# Access Compliance Report

## Public Rights-of-Way

Intersection ID: 14278	Main Street: ROMARE_BEARDEN_DR	Cross Street: FARMER_ST	Location: E
ADA ID: 59DAC868D2C8	Ramp Type: MedianPerp	Initial Pass/Fail: Fail	Overall Compliance: No
Severity Score: 21.25			
Codes/Mitigation Info/Possible Solution		Field Measurements/Component Compliance

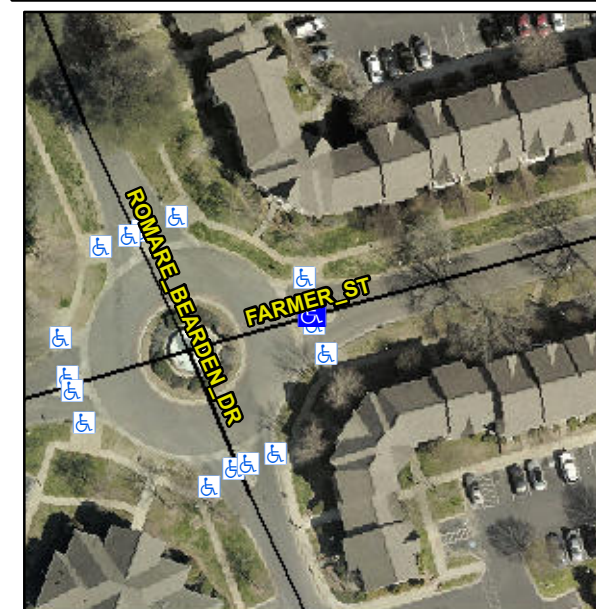
**Not Found, R304.5.1, R304.5.3**

Compliance	Description	Data	Compliance	Description	Data
N/A	Ramp Length (in)	39.0	Yes	Ramp Slope (%)	7.5
No	Ramp Width (in)	45.0	No	Ramp XSlope (%)	5.1
N/A	Flare Type LT	N/A	N/A	Flare Type RT	N/A
N/A	Flare Slope LT (%)	N/A	N/A	Flare Slope RT (%)	N/A
N/A	Flare Traversable LT?	N/A	N/A	Flare Traversable RT?	N/A
N/A	Landing Length (in)	N/A	N/A	DWS Provided?	N/A
N/A	Landing Width (in)	N/A	N/A	DWS Contrast?	N/A
N/A	Landing Slope (%)	N/A	N/A	DWS Length (in)	N/A
N/A	Landing X Slope (%)	N/A	N/A	DWS Full Width?	N/A
N/A	Landing Curb? (Y/N)	N/A	N/A	DWS Offset (in)	N/A
N/A	Shared Landing?	N/A			
N/A	Gutter Ponding?	N/A	N/A	Gutter Slope (%)	N/A
N/A	Gutter Lip Ht (in)	N/A	N/A	Gutter X Slope (%)	N/A
N/A	Painted X Walk1?	No	N/A	Painted X Walk2?	N/A
	X Walk 1 Direction	To N		X Walk 2 Direction	N/A
N/A	X Walk 1 Width (in)	N/A	N/A	X Walk 2 Width (in)	N/A
	X Walk 1 Slope (%)	0.8		X Walk 2 Slope (%)	N/A
	X Walk 1 X Slope (%)	3.5		X Walk 2 X Slope (%)	N/A

**Remove & Replace Entire Ramp.**
